Memorandum

Subject: Draft Santana Ranch Drainage System Peer Review

HDR | WRECO has reviewed the Storm Drain Calculations Santana Ranch Basin A (April 2019), Storm Drain Calculations Santana Ranch Basin B (April 2020), and supporting documentation from O'Dell Engineering as requested. The following summarizes our findings and recommendations in order of priority to reduce flooding along Fairview Road and the properties to the north of the Santana Ranch Development. Details of the reviewed work can be found in the following sections.

Figure 1. County Isohyetal Map

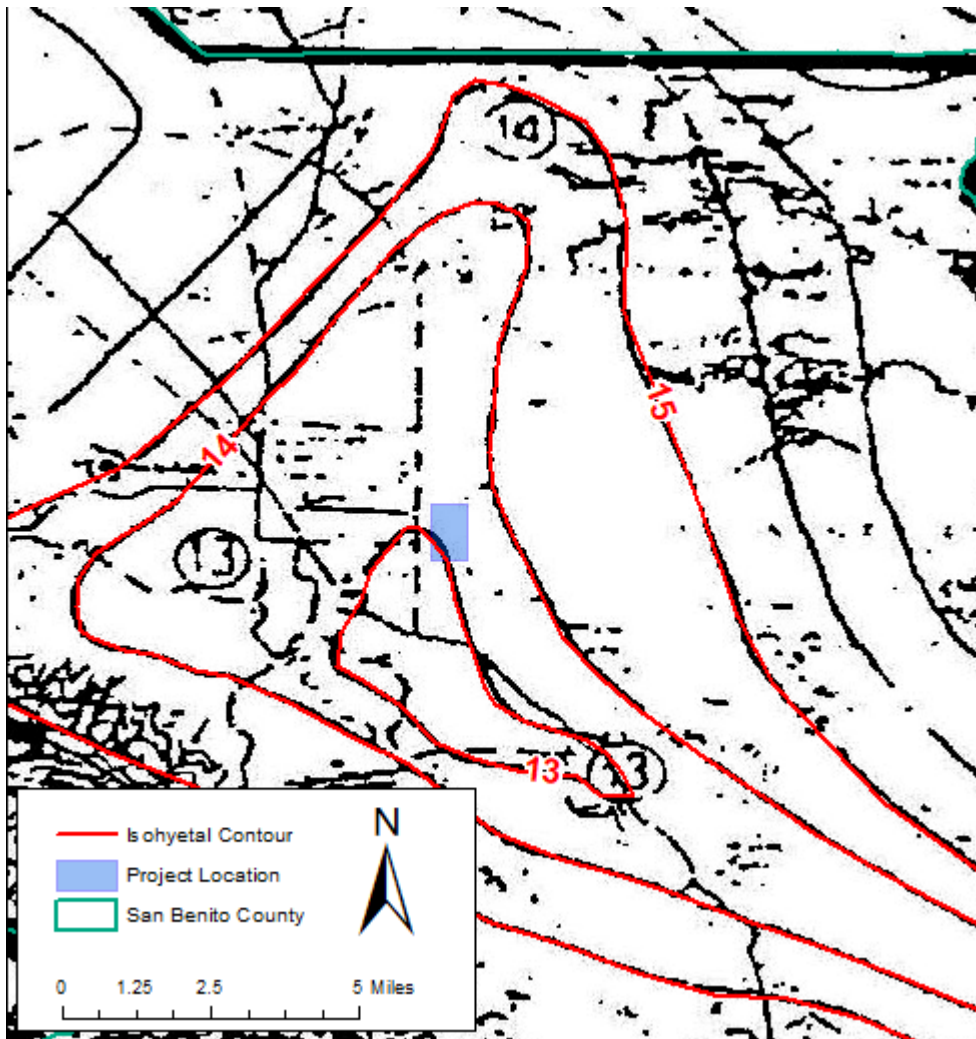
The intensity and rainfall depth for the Project were determined using the County isohyetal map 23.31.041(1), intensity duration chart 23.31.041(2), and volume chart 23.31.041(5) all provided in the Criteria. A mean annual precipitation (MAP) of 14 inches was used for the SD Calculations, however as seen in Figure 1 the Project is located in an area with a MAP of 13 inches. Decreasing the MAP will increase both the intensity and runoff volume.

3. Develop new intensity and rainfall depth values based on MAP equal to 13 inches.
4. Develop a composite runoff coefficient, C, based on the values in Table 1 and the site coverage density for the housing areas.

Figure 2. San Benito County Water District Hollister historical rainfall

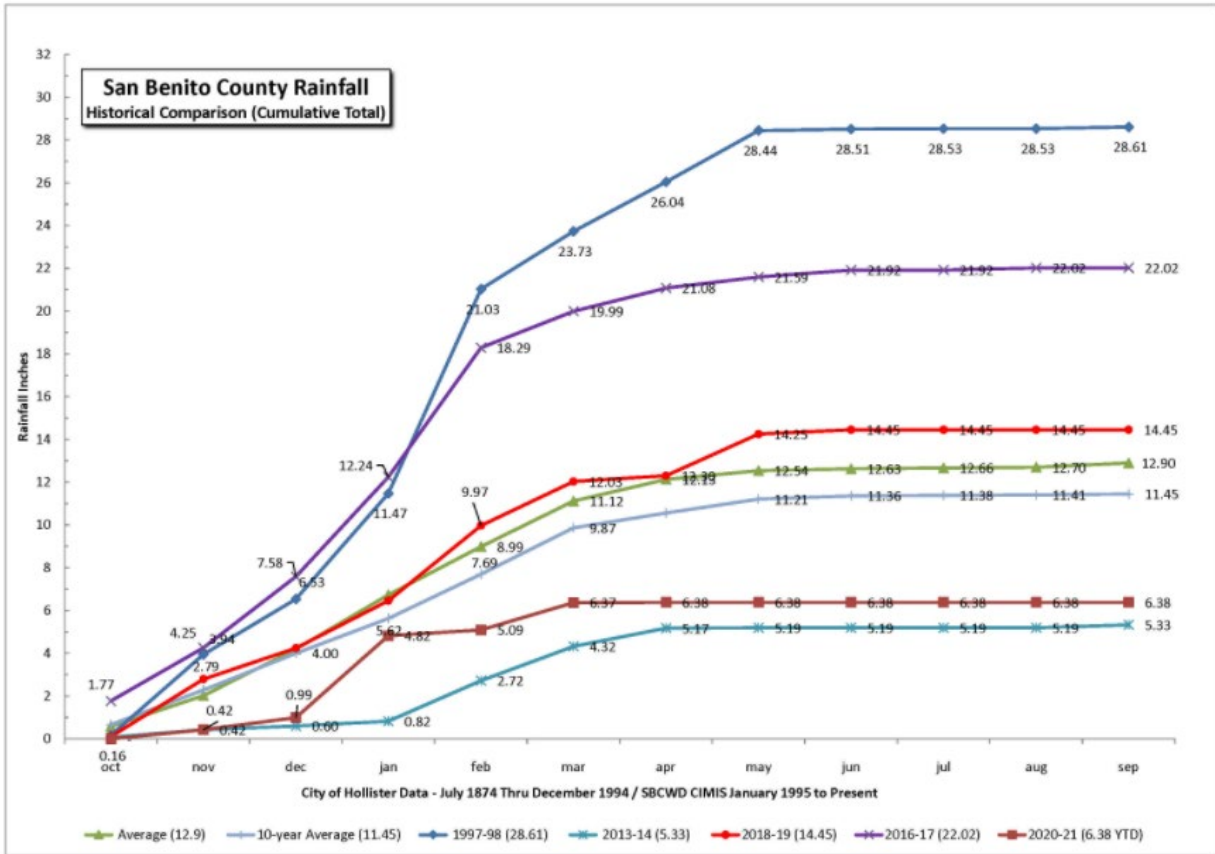
A field investigation was conducted on October 27, 2021. The 24-hour rainfall accumulation at the Hollister Airport rain station was recorded as 7.1 inches on October 25, 2019 (WillyWeather, 2021). As of November 9, 2019, the station has accumulated 22.5 inches (WillyWeather, 2021). According to the San Benito County Water District historical data the average annual rainfall is 12.90 inches (2021) (see Figure 2).

Figure 21. Approximate drainage pattern observed during field investigation

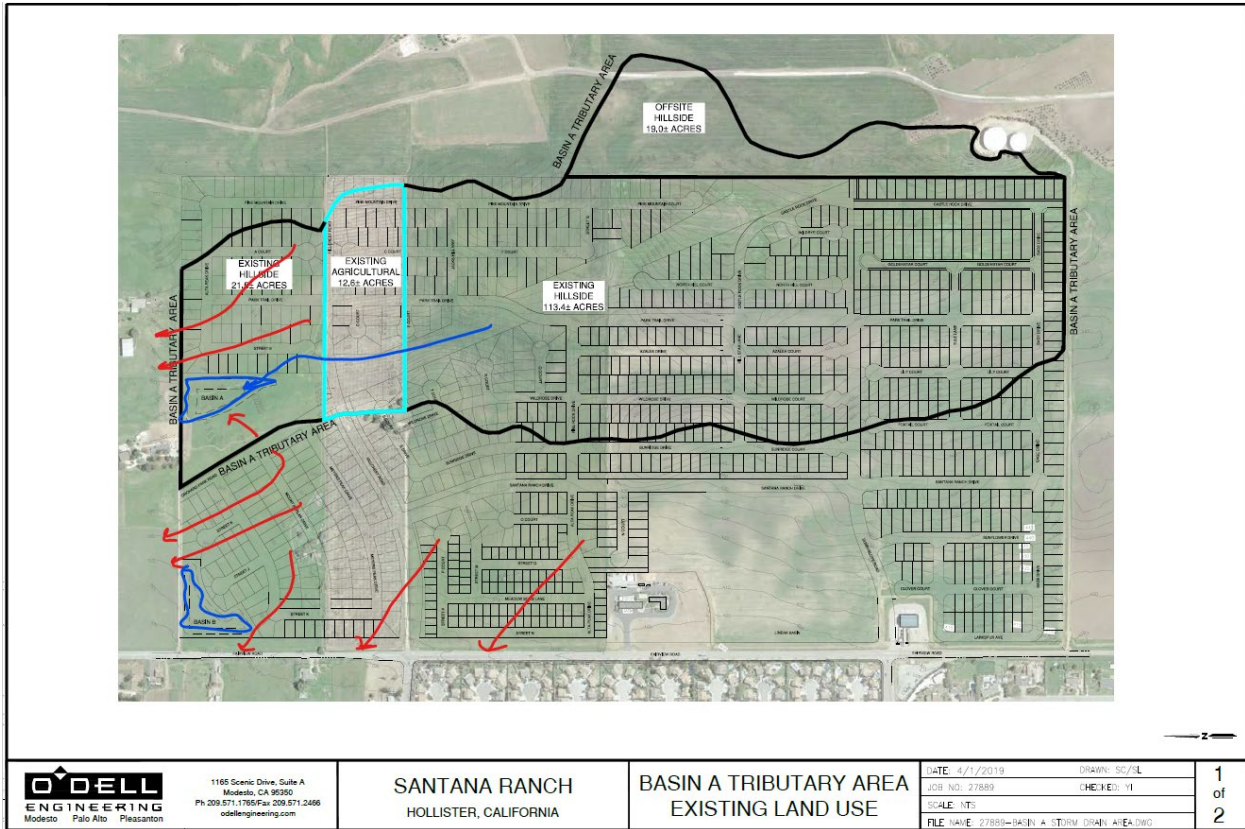
From field observation, it appears that much of the proposed grading in the watershed to Basin A has not been completed and much of the flow from the undeveloped area that will ultimately drain to Basin A appears to bypass Basin A in the interim condition. The bypassed flow appears to concentrate in the historic flow path at the downstream side of the Basin A spillway. See Figure 21 for approximate drainage paths.

Similar to Basin A, the runoff from the undeveloped area south and east of Basin B that is ultimately planned to drain into Basin B appears to bypass Basin B in the interim condition. The bypassed flow appears to split around the basin and concentrate on Fairview road. See Figure 21 for approximate drainage paths.

1. Confirm the roadside ditch on the east side of Fairview Road meets the design guidelines.
2. Finalize grading and install interim or final storm drains to collect and drain runoff to basins.
